Access Compliance Report

Public Rights-of-Way

(Curb Ramps)

Intersection ID: 50584	Main Street: GREAT_LAUREL_RD	Cross Street: GRAND_FIR_RD	Location: SW
ADA ID: 29085EBA380E	Ramp Type: Perp	Initial Pass/Fail: Fail	Overall Compliance: No
Severity Score: 10			
Codes/Mitigation Info/Possible Solution		Field Measurements/Component Compliance

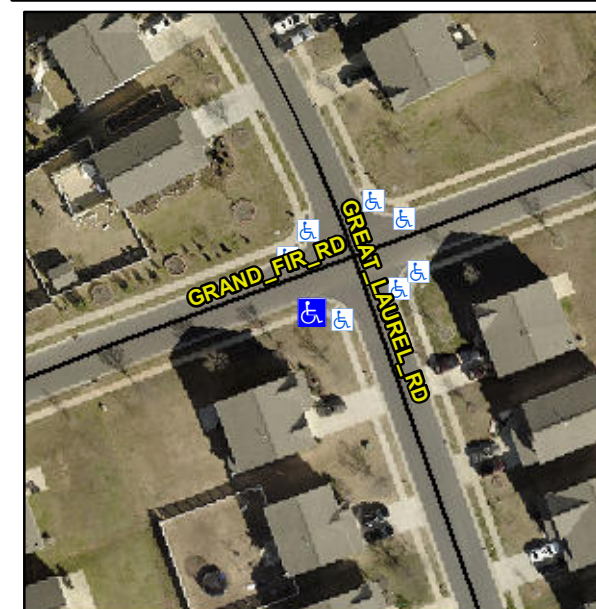
Not Found, R304.5.1

Compliance	Description	Data	Compliance	Description	Data
N/A	Ramp Length (in)	48.0	Yes	Ramp Slope (%)	5.6
No	Ramp Width (in)	46.0	Yes	Ramp XSlope (%)	2.1
N/A	Flare Type LT	N/A	N/A	Flare Type RT	N/A
N/A	Flare Slope LT (%)	N/A	N/A	Flare Slope RT (%)	N/A
N/A	Flare Traversable LT?	N/A	N/A	Flare Traversable RT?	N/A
N/A	Landing Length (in)	N/A	N/A	DWS Provided?	N/A
N/A	Landing Width (in)	N/A	N/A	DWS Contrast?	N/A
N/A	Landing Slope (%)	N/A	N/A	DWS Length (in)	N/A
N/A	Landing X Slope (%)	N/A	N/A	DWS Full Width?	N/A
N/A	Landing Curb? (Y/N)	N/A	N/A	DWS Offset (in)	N/A
N/A	Shared Landing?	N/A			
N/A	Gutter Ponding?	N/A	N/A	Gutter Slope (%)	N/A
N/A	Gutter Lip Ht (in)	N/A	N/A	Gutter X Slope (%)	N/A
N/A	Painted X Walk1?	No	N/A	Painted X Walk2?	N/A
	X Walk 1 Direction	To N		X Walk 2 Direction	N/A
N/A	X Walk 1 Width (in)	N/A	N/A	X Walk 2 Width (in)	N/A
	X Walk 1 Slope (%)	1.5		X Walk 2 Slope (%)	N/A
	X Walk 1 X Slope (%)	2.1		X Walk 2 X Slope (%)	N/A

Remove & Replace Entire Ramp.
